# Vision Composite Knit Ltd (10330)

## Vision Garments Ltd

# Identified Priority 3 Concerns

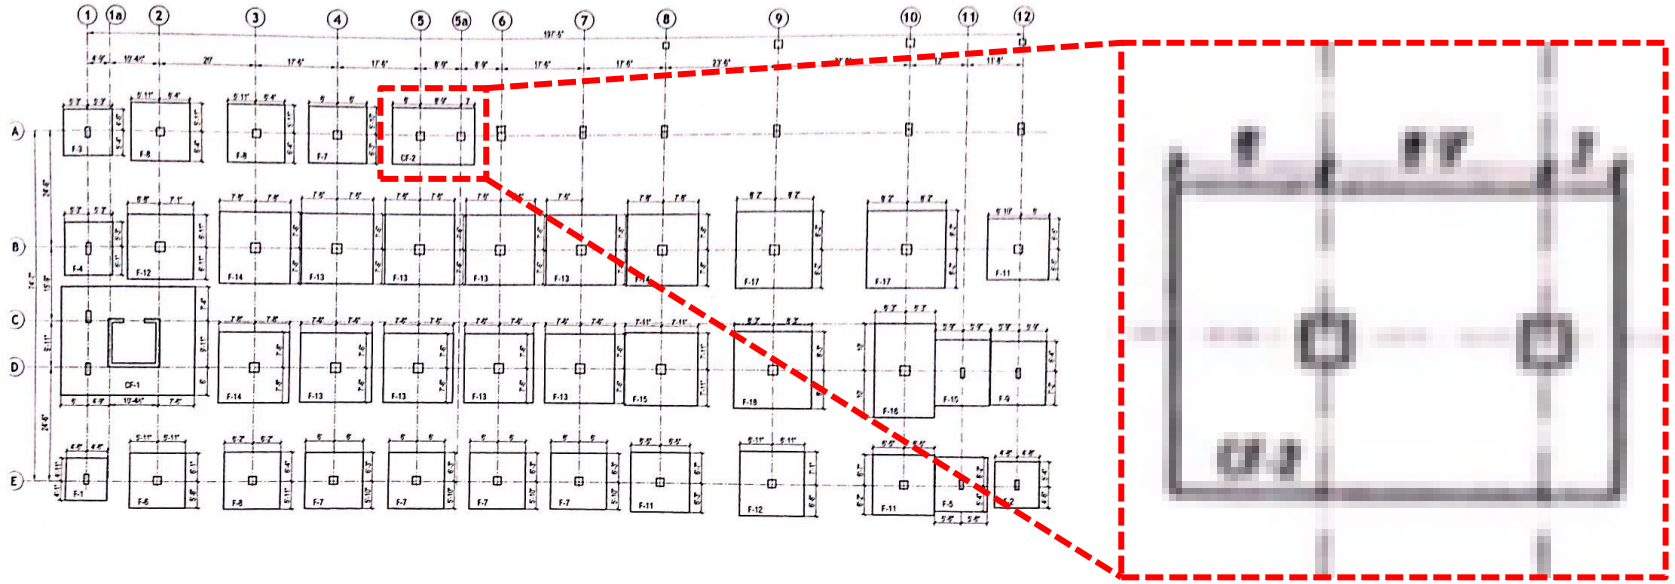
The foundation plans shows a combined footing for the columns at Grid A5 and Grid A5a. However, the detail is missing from the drawings.

**Lack of structural information with regard to the combined footing**

Item No.	Observation	Recommended Action Plan	Recommended Timeline
1	1st Priority 3 - Lack of information regarding the combined footing.	Building Engineer to advise as-built footing detail If necessary, carry out excavation to ascertain the actual layout of the footing.	6-months
